MWO 9-2320-280-20-4

MODIFICATION WORK ORDER

MODIFICATION OF 1-1/4 TON VEHICLES M998 SERIES STEERING COLUMN INSPECTION AND BRACKET INSTALLATION

15 April 1996

FIGURE 1

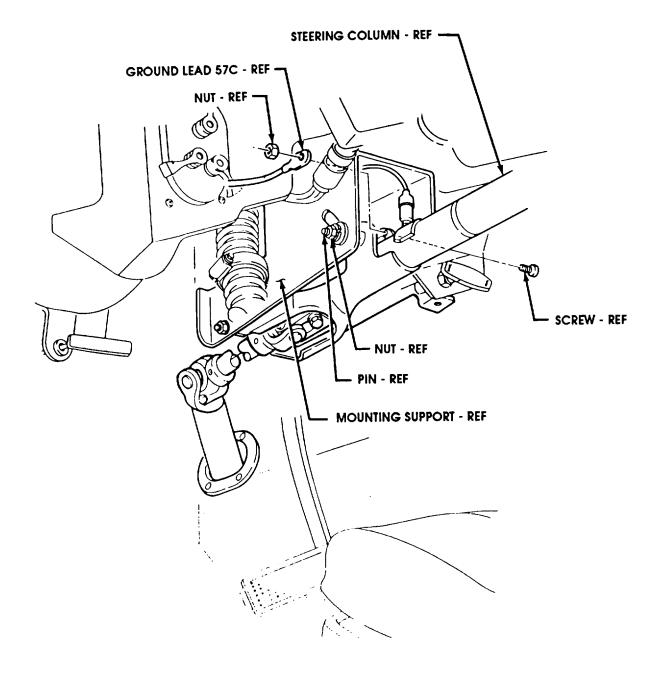
(1) Loosen nut on pin and place steering column in down position on mounting support as shown in figure 1.

- (1) Remove screw, nut, and ground lead 57C from steering column as shown in figure 1.
- (2) Secure ground lead 57C and 12342875 bracket to steering column with 431942 screw and 271169 nut as shown in figure 3. Do not tighten nut.
- (3) Secure 12342876 bracket to bracket (12342875) and steering column with B1821BH025C1OON screw, two MS27183-10 washers, and MS51943-31 nut as shown in figure 3. Tighten nut to 10 lb-ft (14 N•m).
- (4) Tighten nut (271169) installed in step "2" as shown in figure 3.
- (5) Place steering column and pin in upward position on mounting support until steering column cannot be raised any further as shown in figure 5. Tighten nut on pin to 14 lb-ft (19 N•m).

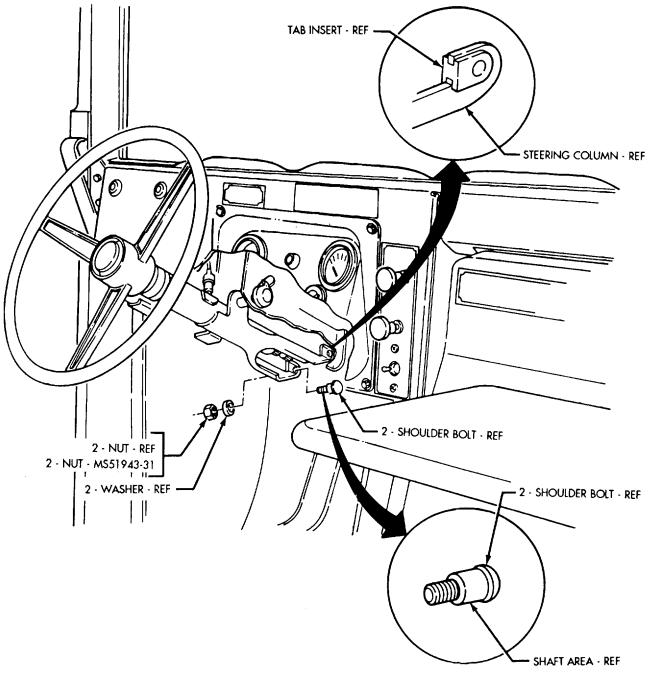
- (2) Remove two shoulder bolts, washers, and nuts from steering column as shown in figure 2.
- (3) Check tab inserts at end of steering column for paint and metal cracking as shown in figure 2. If cracking is present on or around tab inserts, discontinue inspection procedure and replace steering column (Refer to TM 9-2320-280-20).

- Check shoulder bolts removed in step "2" for "mushrooming" around shaft area of shoulder bolt as shown in figure 2. If mushrooming is present, replace shoulder bolts, washers, and nuts (Refer to TM 9-2320280-20).
- If mushrooming is not present, perform step "4".
- (4) Install two existing shoulder bolts, washers, and two MS51943-31 nuts as shown in figure 2. Tighten nuts to 10 lb-ft (14 N-m).

FIGURE 4

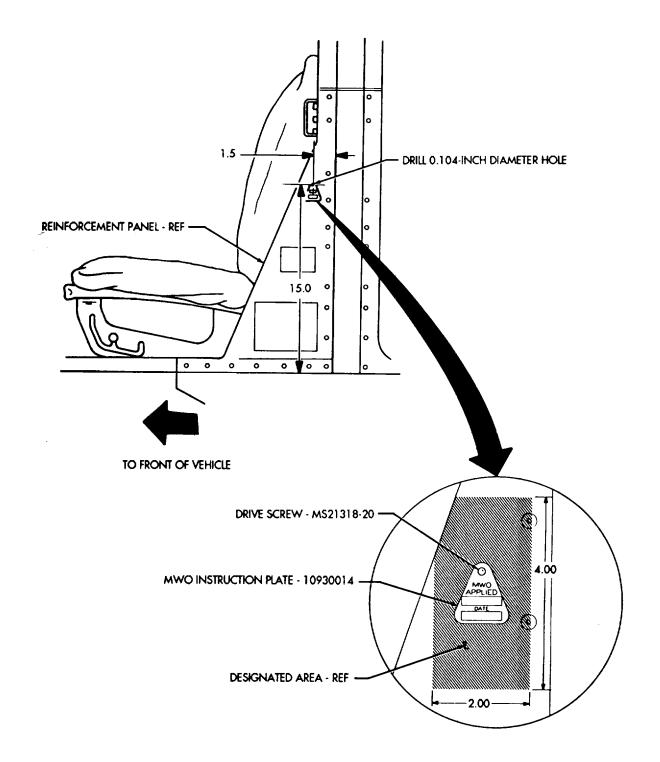
- (2) Install 10930014 MWO instruction plate by drilling a 0.104-inch diameter hole within designated area on body reinforcement panel and secure with MS21318-20 drive screw as shown in figure 4.
- (3) After drive screw is installed, flatten or remove any protruding drive screw material from inside of body reinforcement panel.
- c. Identification Data.

FIGURE 5

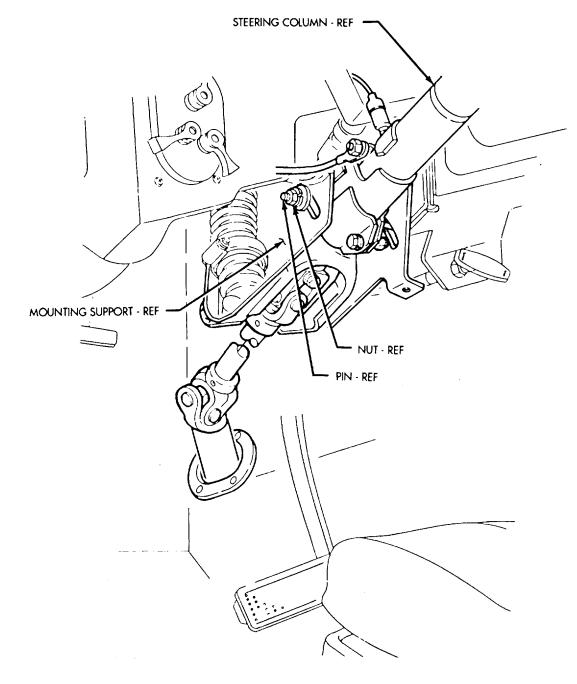
a. When installed correctly, the steering column brackets will appear as shown in figure 5.
